MECKLENBURG COUNTY HEALTH DEPARTMENT
ENVIRONMENTAL HEALTH DIVISION

Application for an
Installation, Construction, Alteration, and/or Repair Permit
(Individual Septic Tank System with Subsurface, Soil Absorption, Effluent Discharge)

MECKLENBURG COUNTY
DEPARTMENT OF ENVIRONMENTAL HEALTH
INSTALLATION, CONSTUCTION, ALTERATION, AND/OR REPAIR PERMIT
(Individual Septic Tank System with Subsurface, Soil Absorption, Effluent Discharge)

CERTIFICATE OF APPROVAL

PLOT OF SYSTEM

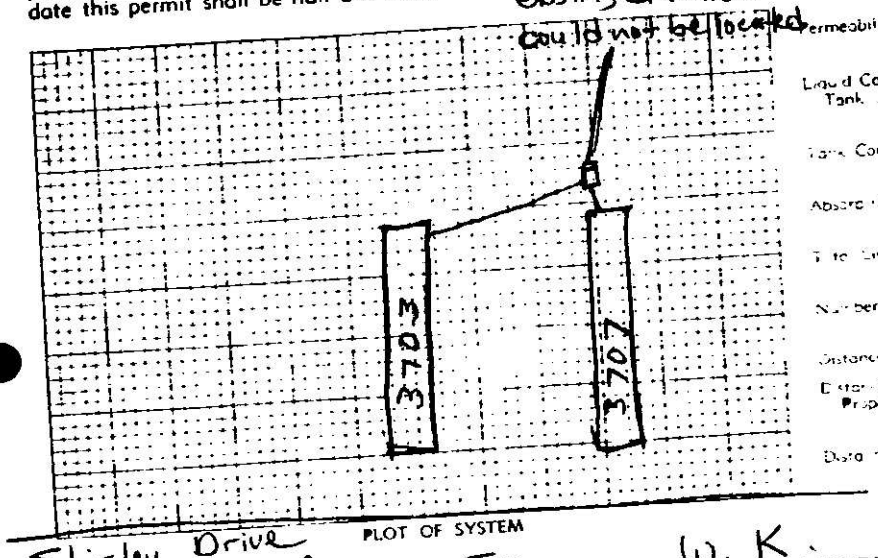
Comments: overflow from the existing drainfield or "tee" of the septic tank + install a 6'wide × 21' long × 6" sand + 47" stone repair

Trench Line Length 125'

Number of Lines 2
